March 20, 2018  
15045

**Third Party Review of the Rezoning Petition in Northern Aroostook County, Fish River Chain of Lakes Concept Plan**

### SLOPE EVALUATION OF FISH RIVER CHAIN OF LAKES DEVELOPMENT AREAS

LOCATION: CROSS LAKE C	FOR: J.D. IRVING LIMITED	INFORMATION: 2011 LIDAR DERIVED DATA PROVIDED BY J.D. IRVING, LIMITED
---------------------------	-----------------------------	--

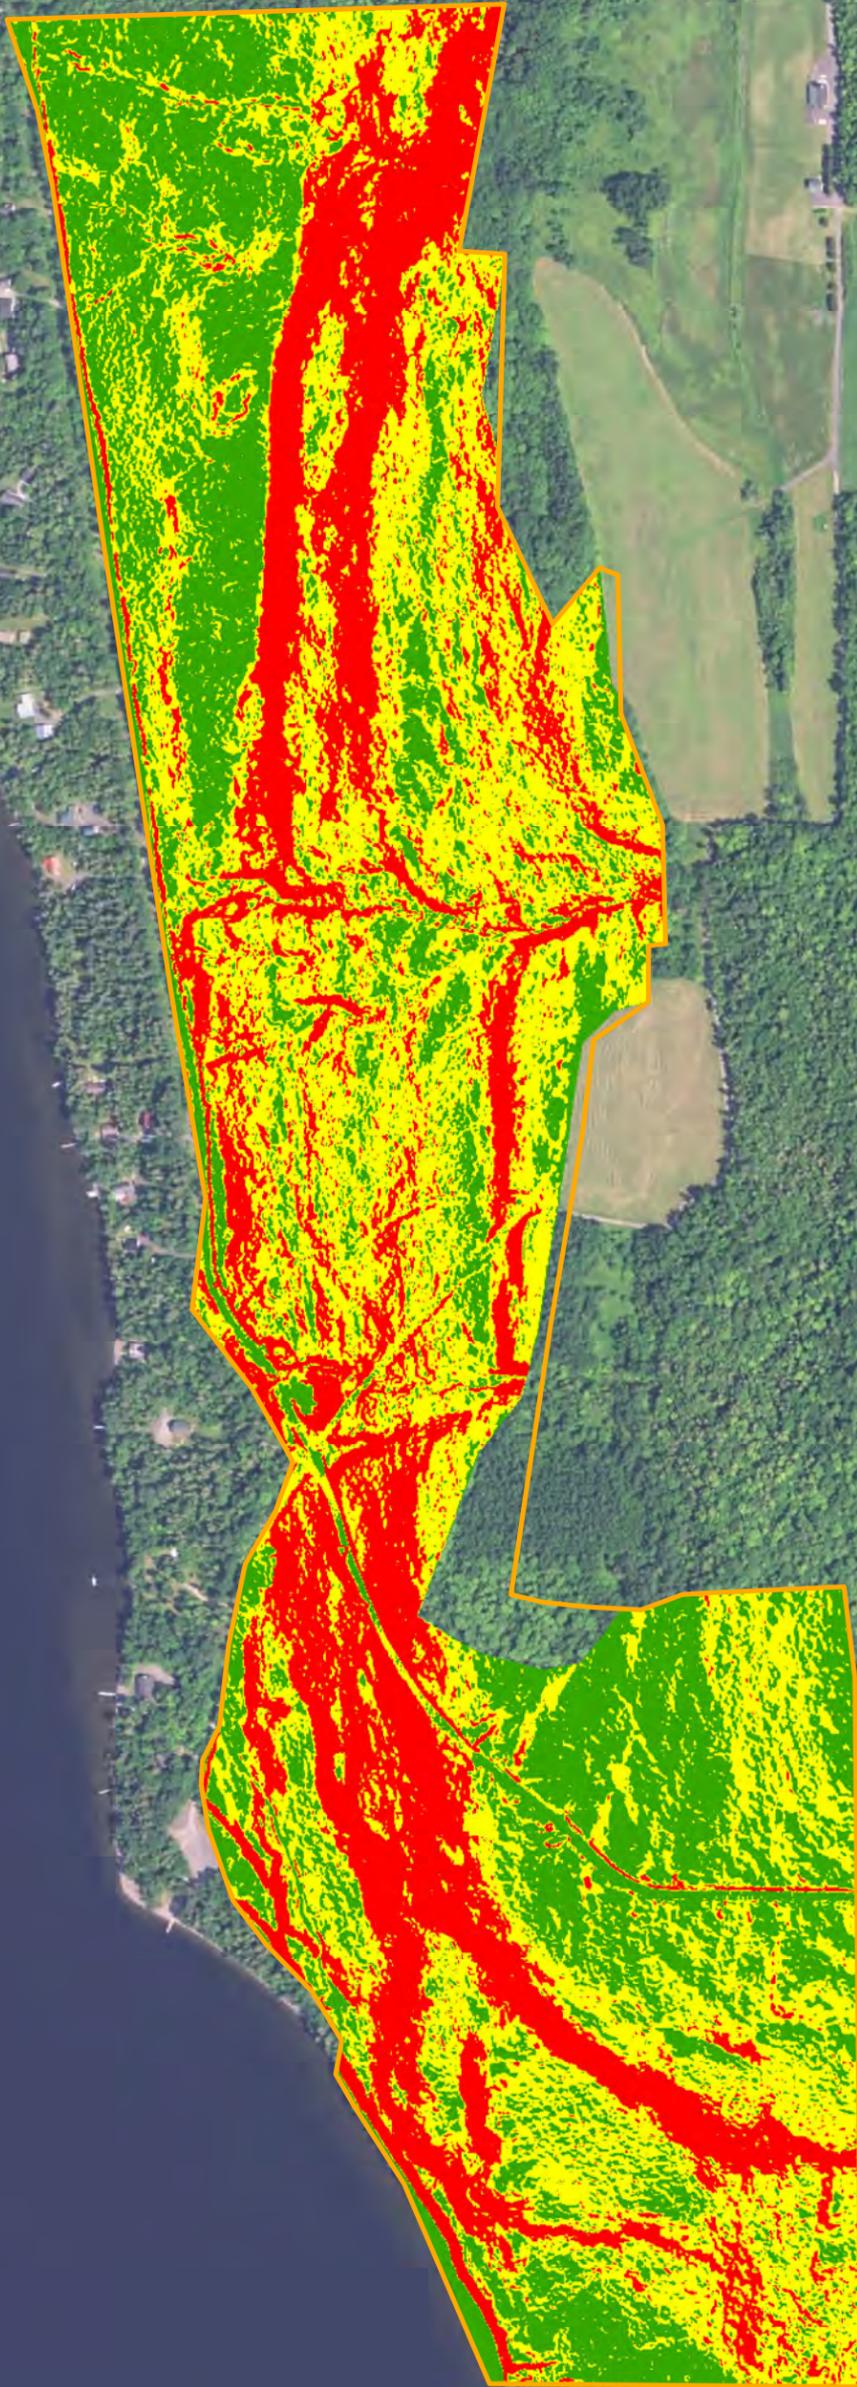
1. Slope Analysis: The slope analysis indicates approximately .44 acres of the development area contains slopes greater than 20 percent and are considered unsuitable for development. The greater than 20% slopes are few and likely associated with random slope features. Slopes 0-10% slopes encompass approximately 54.8 acres. Limited suitability slopes (10 to 20% slopes) encompass approximately 3.2 acres of the project area. The slope assessment suggests the development area is suitable for the intended purposes noting that the few slopes greater than 20% are not considered suitable for development due to limitations for wastewater disposal systems, erosion and drainage control considerations and slope stability. These areas are very few and will have little or no influence on development.

2. The soils in this development area (NRCS Mapping) include PgB (Plaisted gravelly loam) and MoB (Monarda-Burnham complex) soil series. The PgB soils generally gravelly loams and located on slopes 3% to 8%. These soils are generally well drained with a water table over 26 inches and considered a hydrologic group "C" soils. These soils types do not suggest any significant limitations for development beyond localized limitations as a result of a higher-grade soil mapping. The MoB soils are silt-loams, poorly drained and generally have a water table of 0 to 12." The MoB soils present severe limitation for septic systems and would require substantive engineering for dewatering and addressing erosion and stormwater management.

Considering the soils and associated development limitations our assessment suggests that the project area and number of planned units (30) yields an effective net density of .6 acres/unit. While the total land area would accommodate the LUPC dimensional requirements of 40,000 square feet per lot, the soil and slope restrictions allow for lessor net density of approximately 20,000 square feet of net developable area per lot. This represents a fairly compact development density (Please refer to the development matrix analysis appended to this report). This assessment includes deductions for slopes over 20% and allowing for 25% of the 10% to 20% (limited suitability slopes) to be considered not suitable.

The constraints of this site will require special attention to development planning, layout and the management of stormwater/erosion to meet Maine DEP chapter 500 regulations and may include nitrate studies with potential nitrate mitigation to protect both the lake and private drinking water wells.

In conclusion, we recommend further investigation of MoB mapped soil area to verify the available development area and for the presence of restrictive soils impacting the planning, layout and configuration of development.

LOCATION: CROSS LAKE D		FOR: J.D. IRVING LIMITED	INFORMATION: 2011 LIDAR DERIVED DATA PROVIDED BY J.D. IRVING, LIMITED
------------------------	--	--------------------------	---

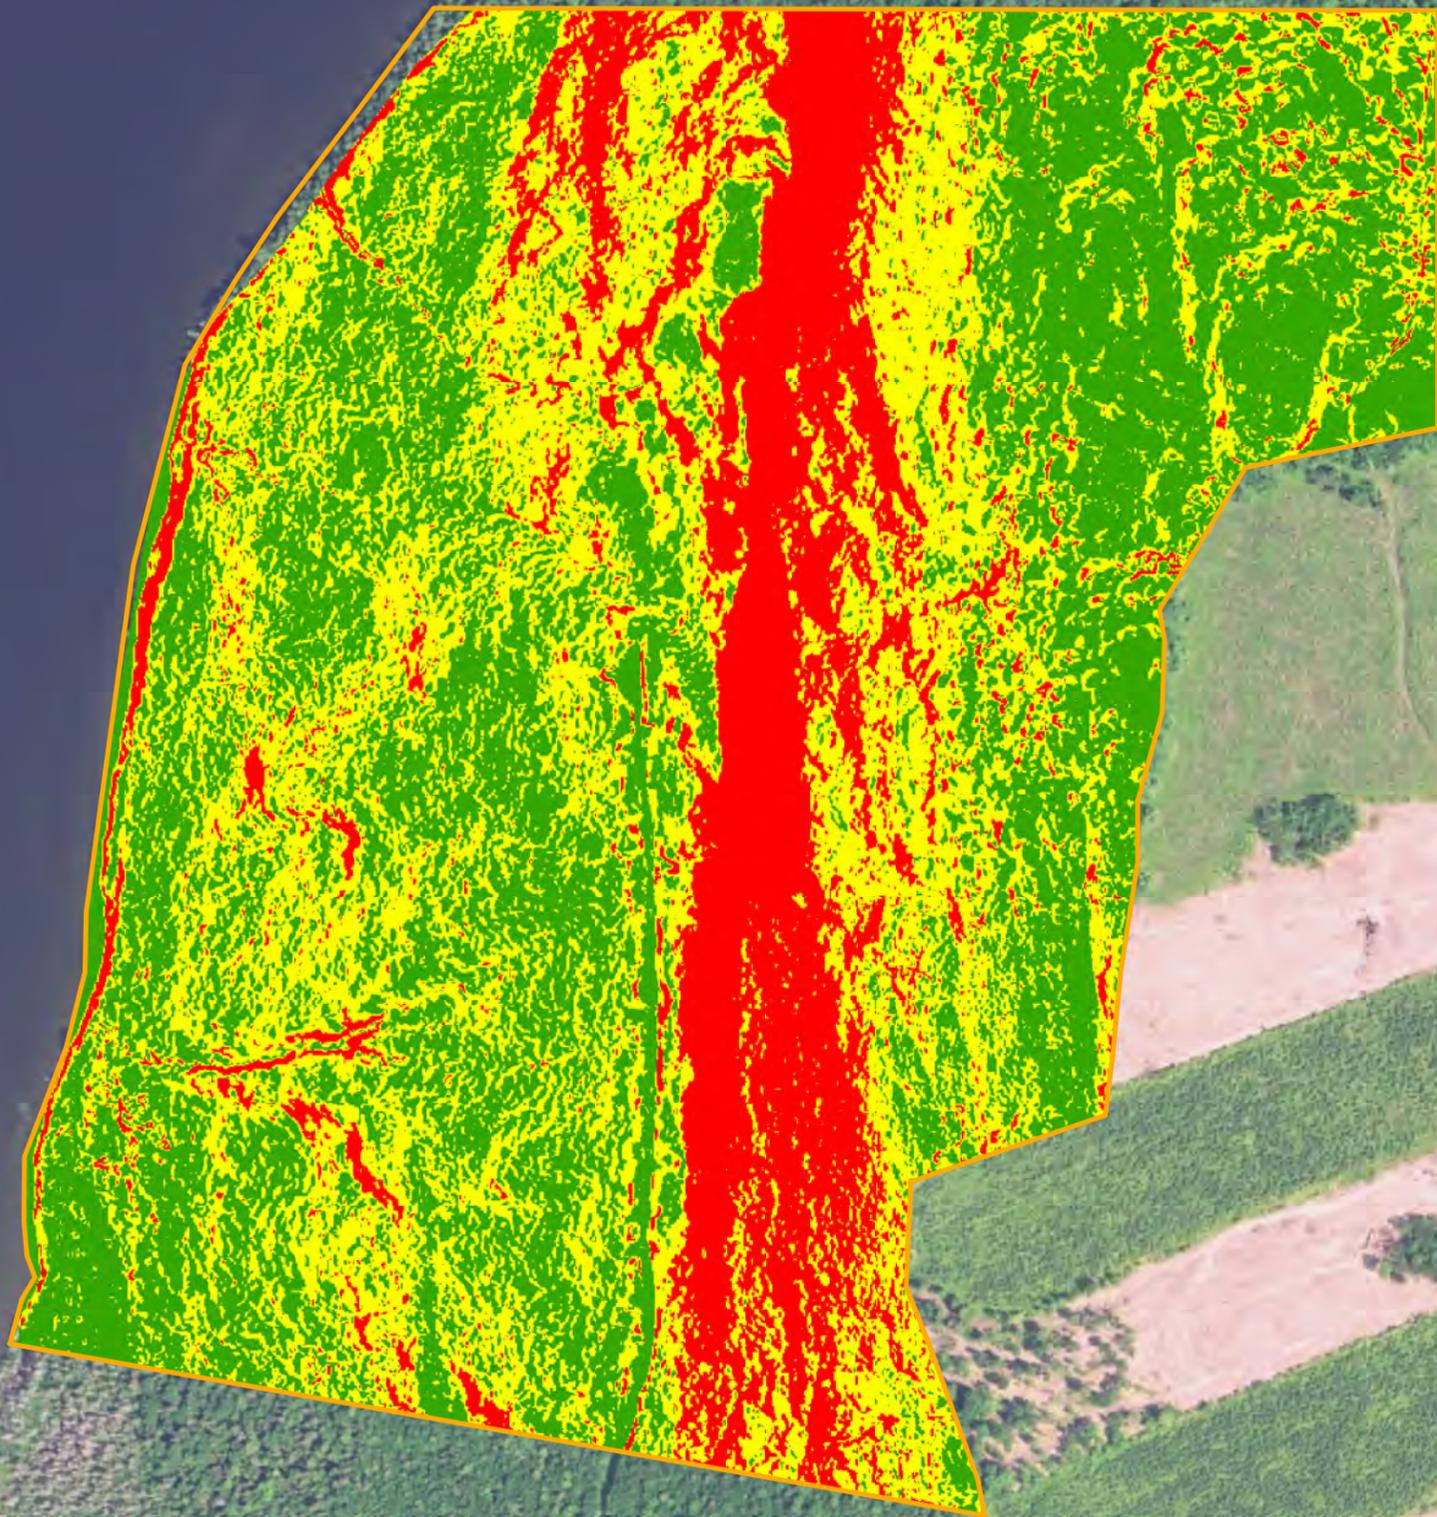
1. Slope Analysis: The slope analysis indicates approximately 49.2 acres of the development area contains slopes greater than 20 percent and are considered unsuitable for development. Slopes 0-10% slopes encompass approximately 54.7 acres. Limited suitability slopes (10 to 20% slopes) encompass approximately 75.8 acres of the project area. The slope assessment suggests the overall parcel is constrained due to slopes with the over 20% slopes consisting of linear features throughout the development area. The slopes of 0-10% are predominately located in the north westerly and south easterly region of the parcel. Given the orientation and locations of the steep and moderately steep slopes, it is expected the development areas will predominantly occur in the identified 0-10% slope area. As a result, the effective development area due to slopes is significantly less than the 185 acres of the overall parcel area. This suggests the relatively low density of 35 units is reasonable for this parcel.

2. The soils in this development area (NRCS Mapping) include PgB/PgC/PgD/PgE (Plaisted gravelly loam), MoB (Monarda-Burnham complex) and HoB/HoC (Howland gravelly loam) soil series. The Pg soils generally gravelly loams and located on slopes 3% to 60% (B-E slope designation). These soils are generally well drained with a water table over 26 inches and considered a hydrologic group "C" soils. These soil types do not suggest any significant limitations for development beyond localized limitations as a result of a higher-grade soil mapping and steep slopes. The MoB soils are silt-loams, poorly drained and generally have a water table of 0 to 12." The MoB soils are considered not suitable for development due to the depth to groundwater, potential presence of wetlands and erosion potential. The HoB and HoC soils are generally gravelly loams and located on slopes 3% to 8% and 8% to 15% respectively. These soils are generally moderately well drained to well drained with a water table over 16 inches and considered a hydrologic group "C/D" soils.

Considering the soil types and associated development limitations including slopes over 20%, our assessment suggests that the project area and number of planned units (35) yields an effective net density of 1.9 acres/unit. This represents a reasonable and appropriate net development density (Please refer to the development matrix analysis appended to this report) recognizing that significant areas of the 187 acres will be constrained and not suitable for development. This suggests the development units will most likely be located in the north westerly and south easterly portions of the site. This assessment includes deductions for slopes over 20% and allowing for 25% of the 10% to 20% (limited suitability slopes) to be considered not suitable.

LOCATION: CROSS LAKE E	FOR: J.D. IRVING LIMITED	INFORMATION: 2011 LIDAR DERIVED DATA PROVIDED BY J.D. IRVING, LIMITED	SCALE: 1" = 400'
			DATE: 03/08/18

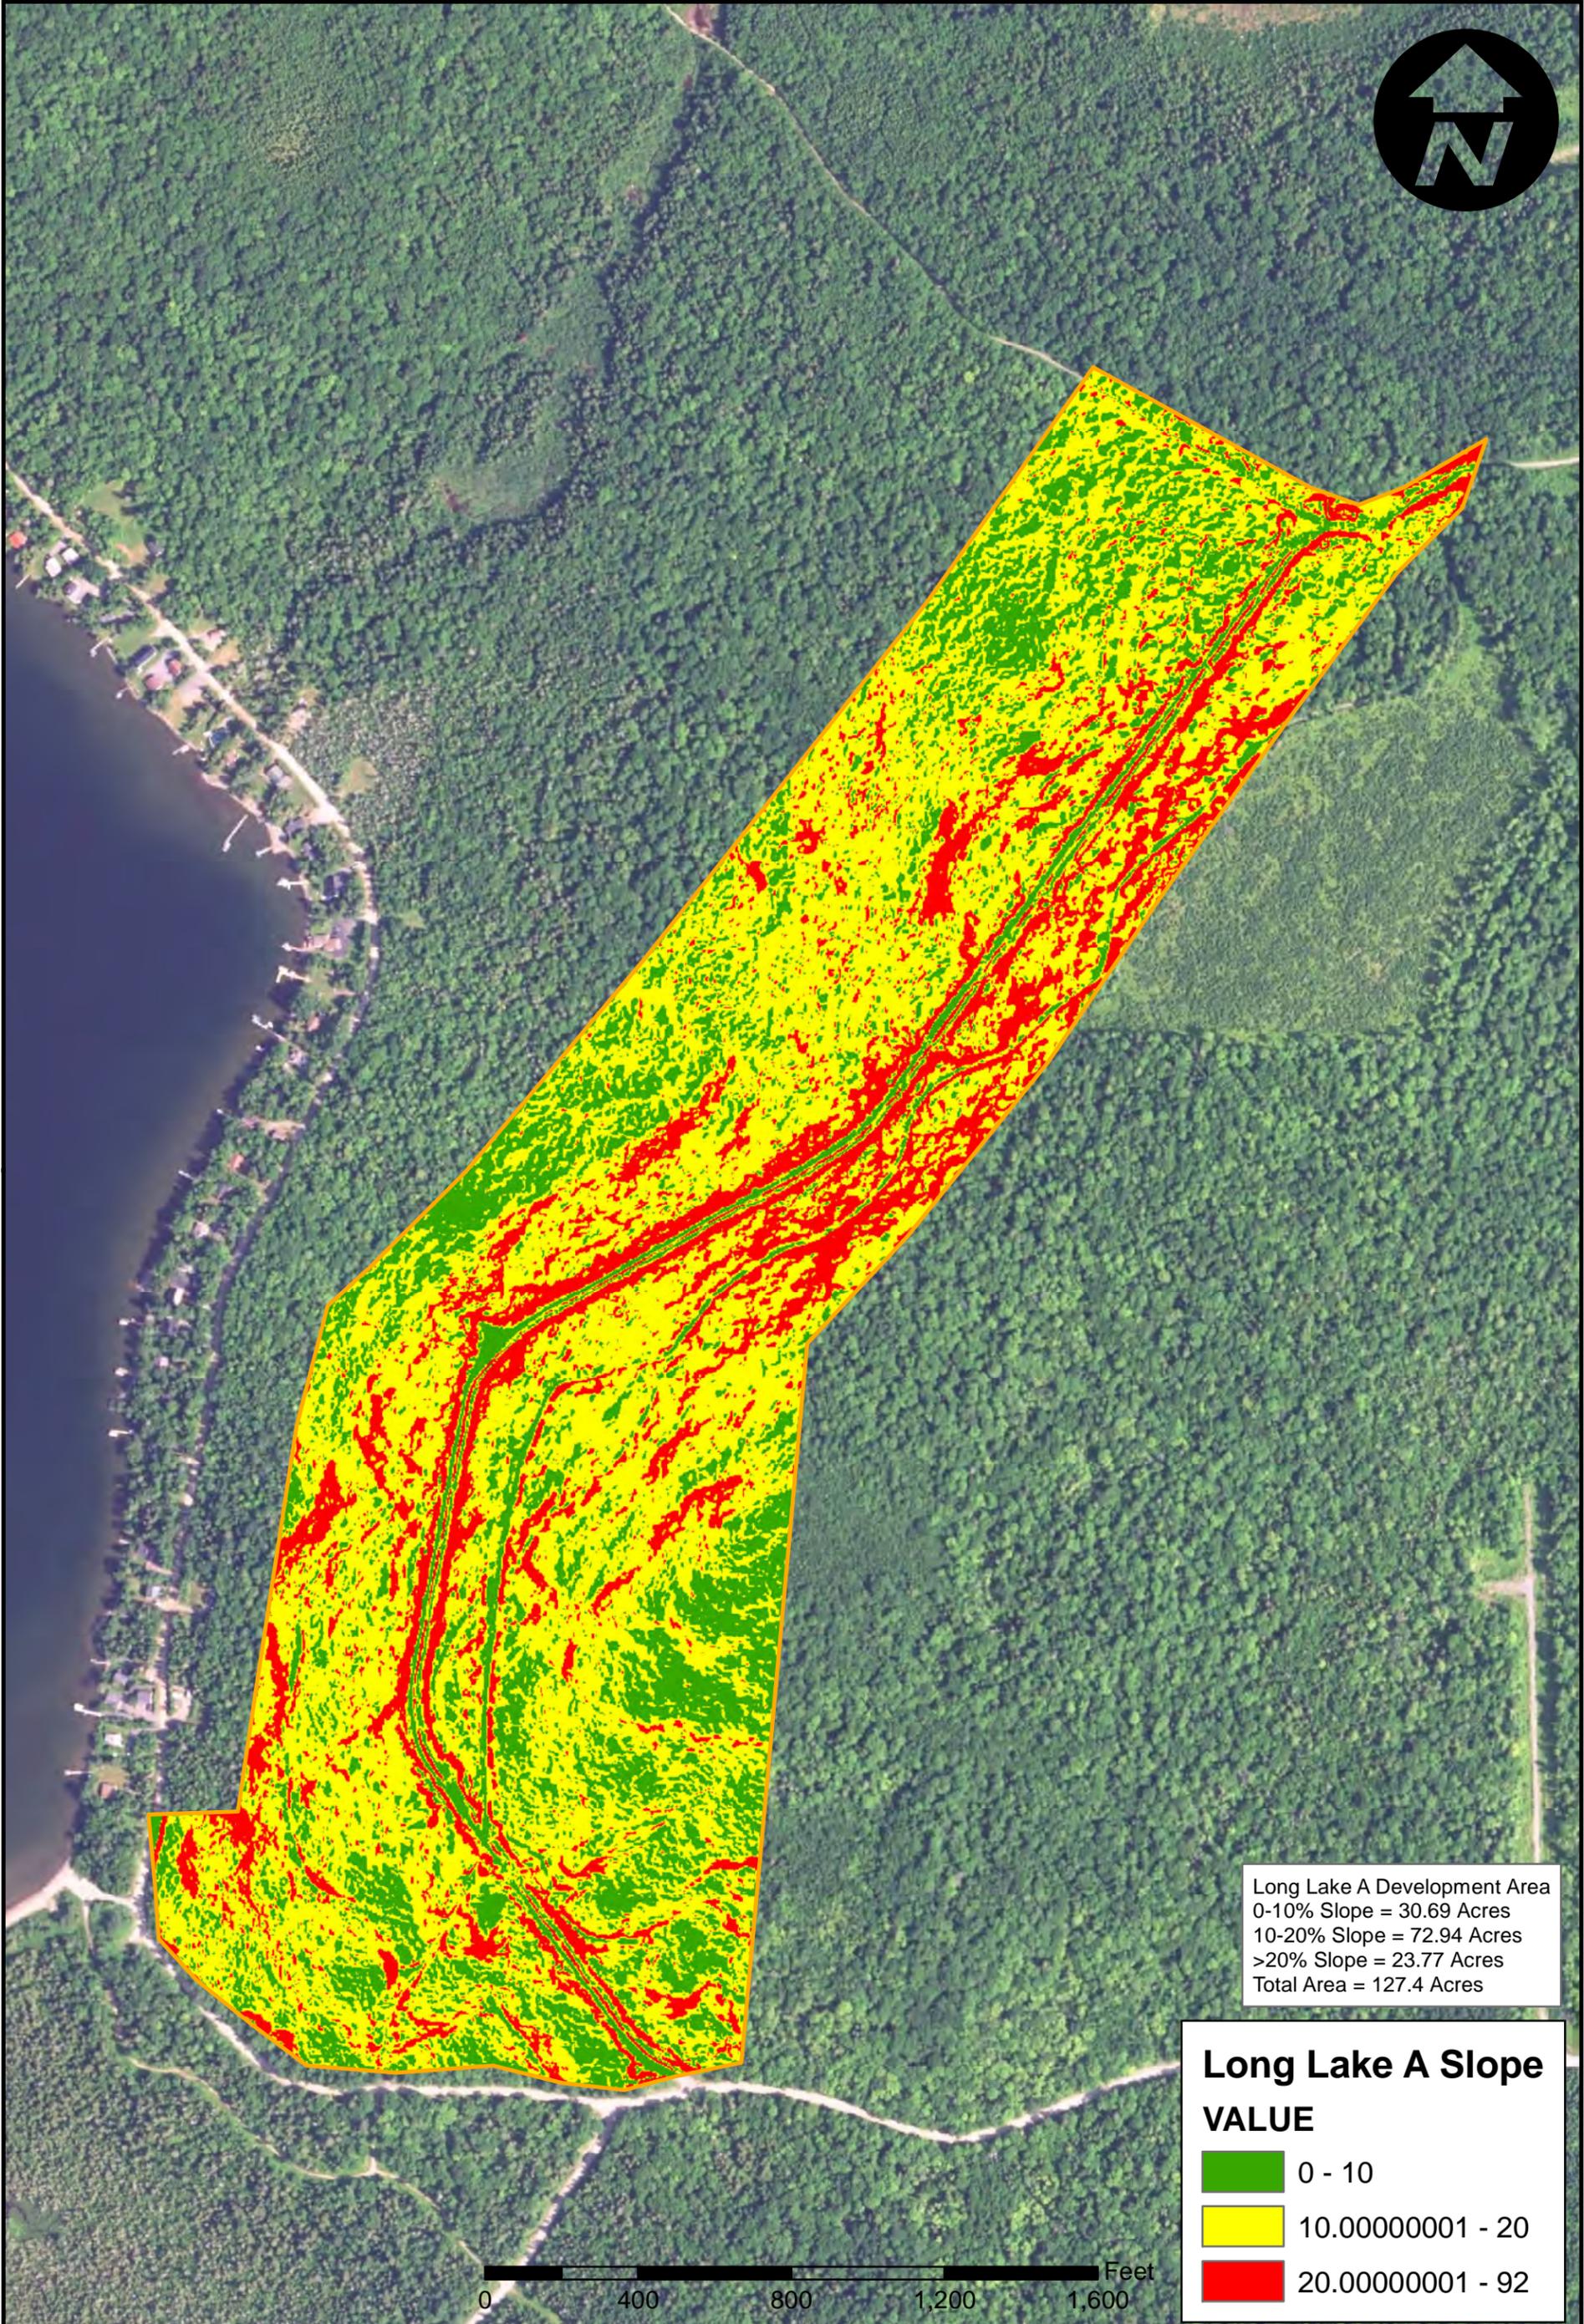
1. Slope Analysis: The slope analysis indicates approximately 32.4 acres of the development area contains slopes greater than 20 percent and are considered unsuitable for development. Slopes 0-10% slopes encompass approximately 66.4 acres. Limited suitability slopes (10 to 20% slopes) encompass approximately 64.3 acres of the project area. The slope assessment suggests the over 20 percent slopes are primarily located in north-south orientation running parallel to the lake just easterly of the center of the parcel. As a result, development areas are expected to either side of this steep slope feature. The slopes of 0-10% and 10-20% comprise the majority of the parcel and represent slope areas suitable for the intended unit density.

2. The soils in this development area (NRCS Mapping) include PgB/PgD (Plaisted gravelly loam), MoB (Monarda-Burnham complex) and HvB/HvC (Howland loam) soil series. The Pg soils generally gravelly loams and located on slopes 3% to 8% and 15% to 30% (B and D slope designation). These soils are generally well drained with a water table over 26 inches and considered a hydrologic group "C" soils. These soil types do not suggest any significant limitations for development beyond the steep slope areas and localized limitations as a result of a higher-grade soil mapping.

The MoB soils are silt-loams, poorly drained and generally have a water table of 0 to 12.” The MoB soils are considered not suitable for development due to the depth to groundwater, potential presence of wetlands, erosion potential and development limitations. The HvB and HvC soils are generally very stony loams and located on slopes 3% to 8% and 8% to 15% respectively. These soils are generally moderately well drained to well drained with a water table of 17 to 26 inches and considered a hydrologic group “C/D” soils.

Considering the soil types and associated development limitations including slopes over 20%, our assessment suggests that the project area and number of planned units (60) yields an effective net density of 1.4 acres/unit. This represents a reasonable and appropriate net development density (Please refer to the development matrix analysis appended to this report). This assessment includes deductions for slopes over 20% and allowing for 25% of the 10% to 20% (limited suitability slopes) to be considered not suitable.
